CONSTRUCTION PLANS FOR

NOR ESTE MANOR SUBDIVISION

DRAINAGE, GRADING, PAVING AND UTILITY
IMPROVEMENTS

NOTE:
SHEETS AFFECTED BY CHANGE ORDER #1
AS INDICATED

DRAWING NO. 3355
MAP NO. C-19
SHEET 30 OF 52

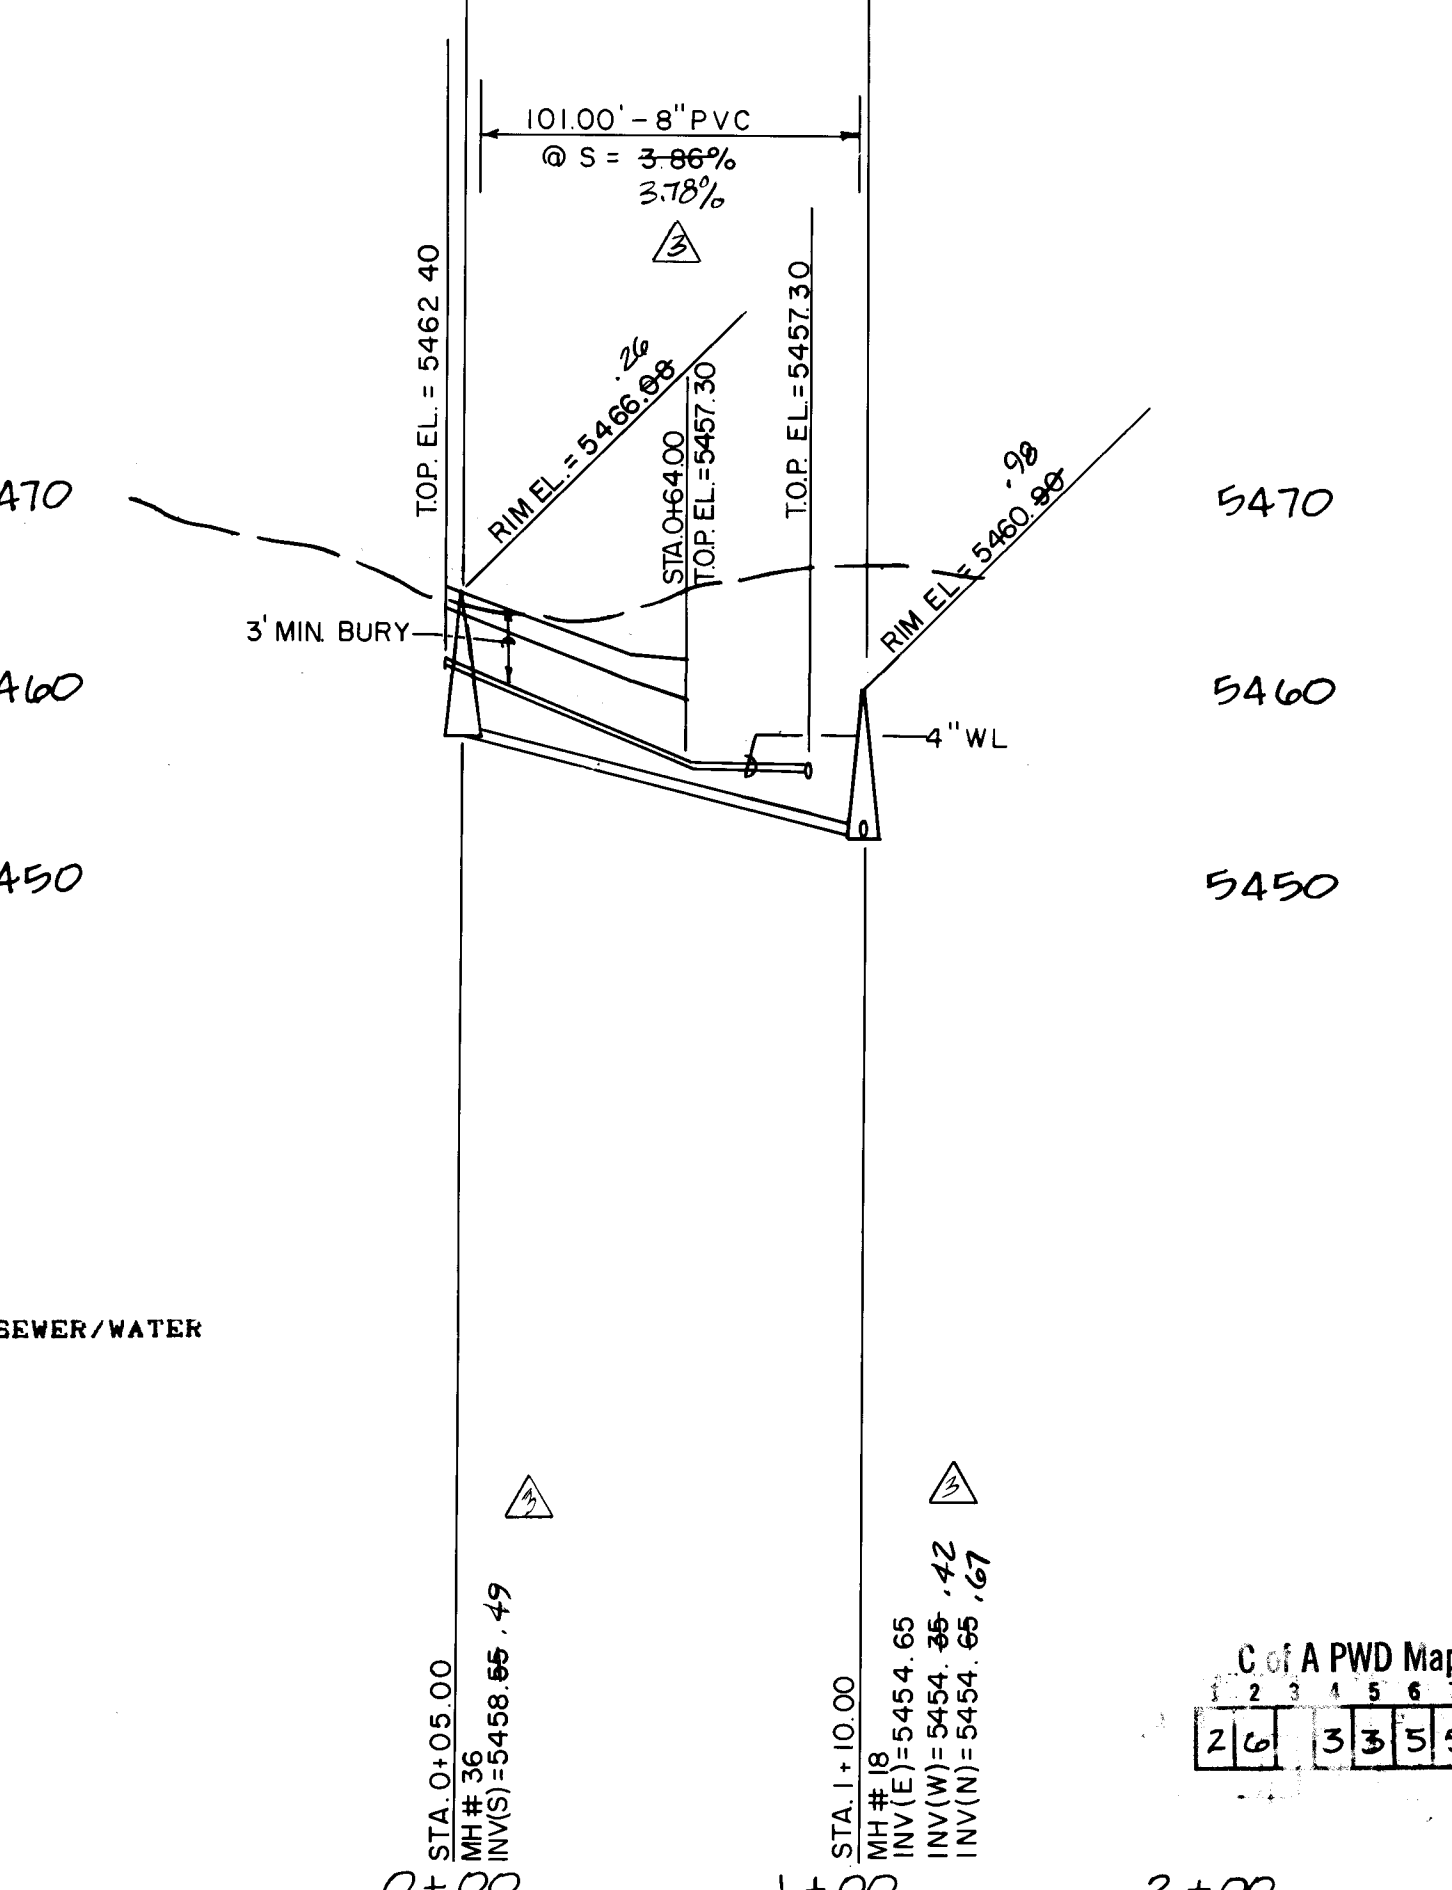
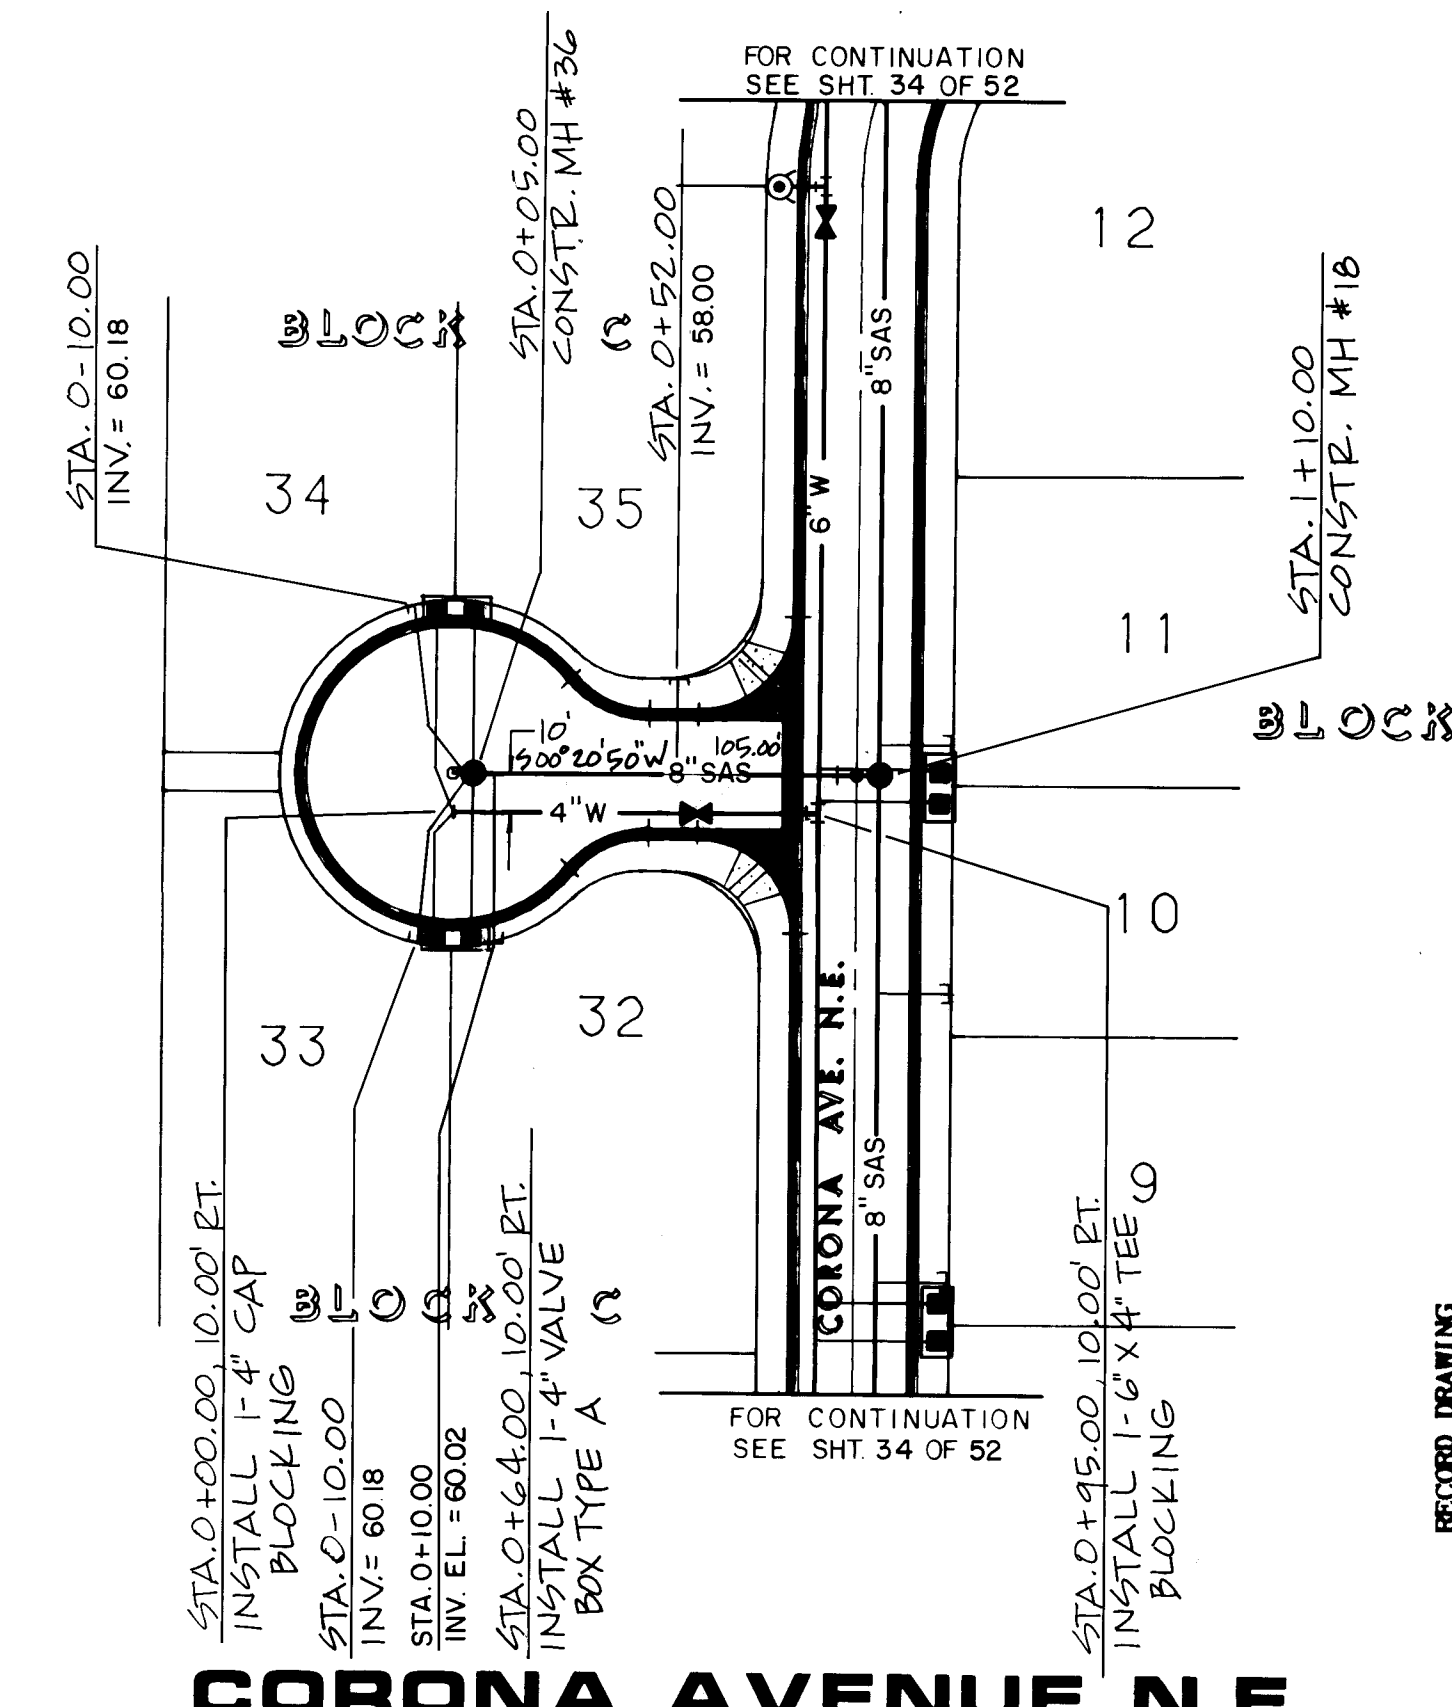
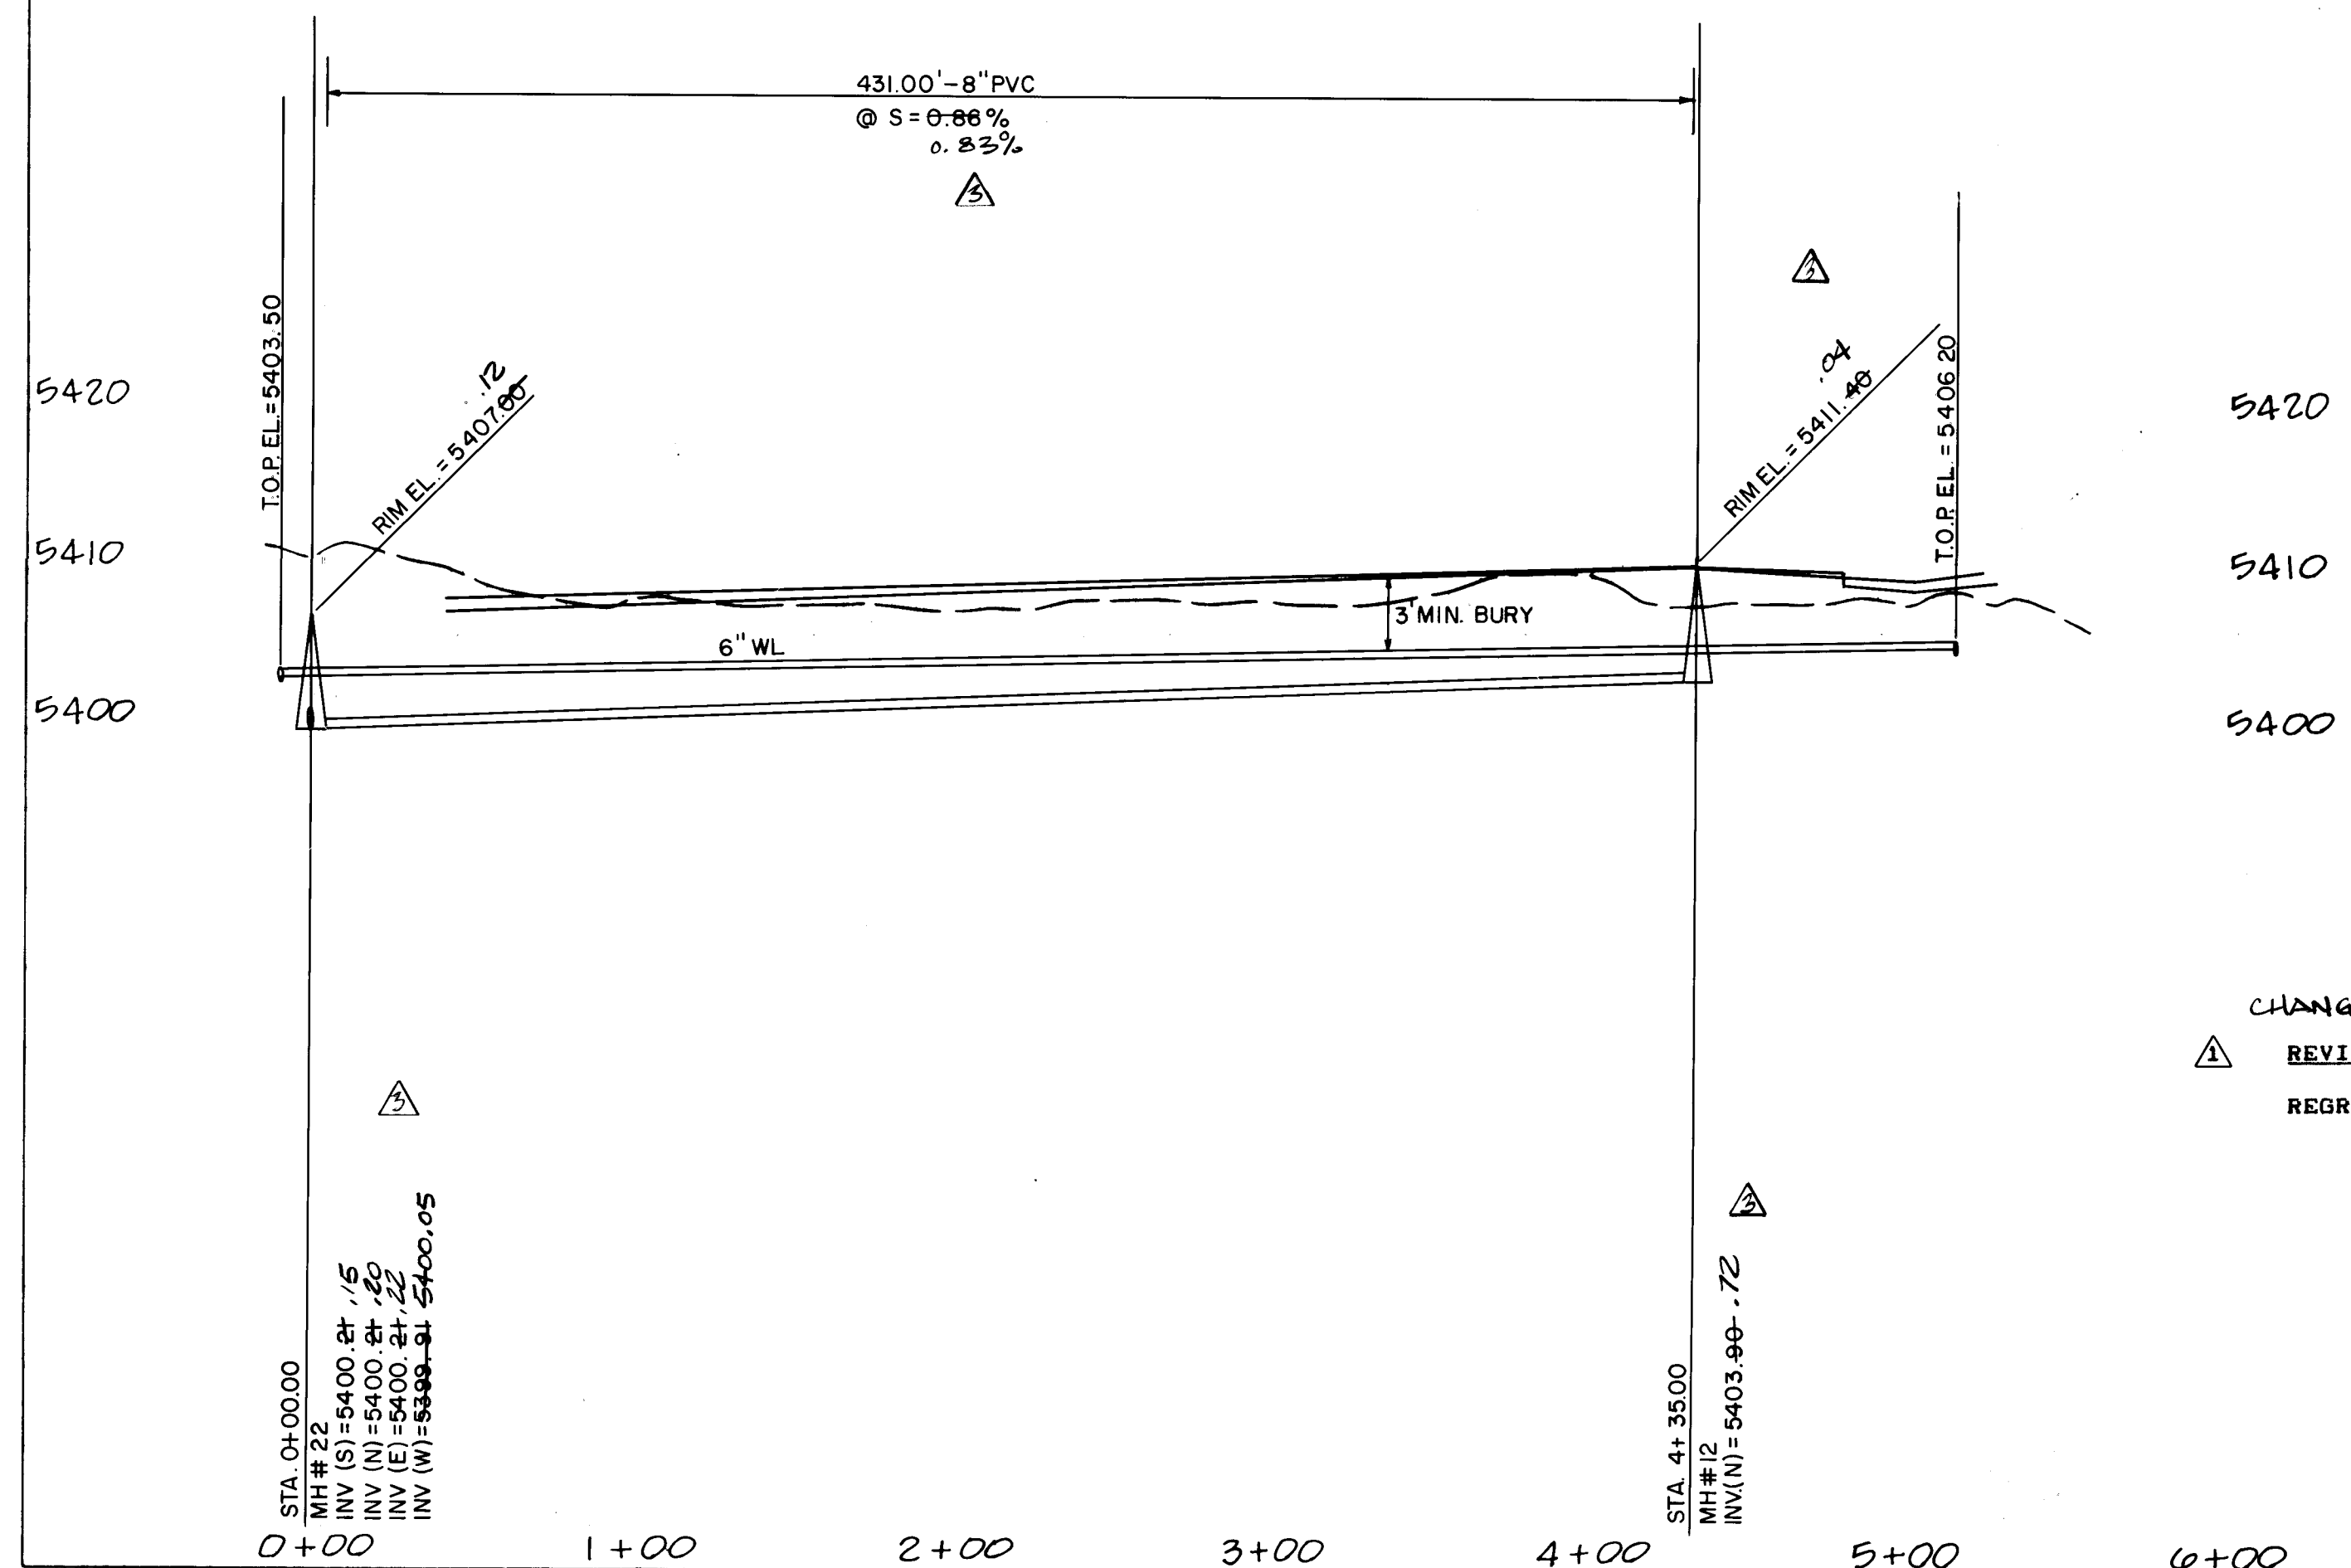
CHANGE ORDER No. 1
 REVISIONS
 REGRADE HELEN HARDIN AND CORONA SEWER/WATER
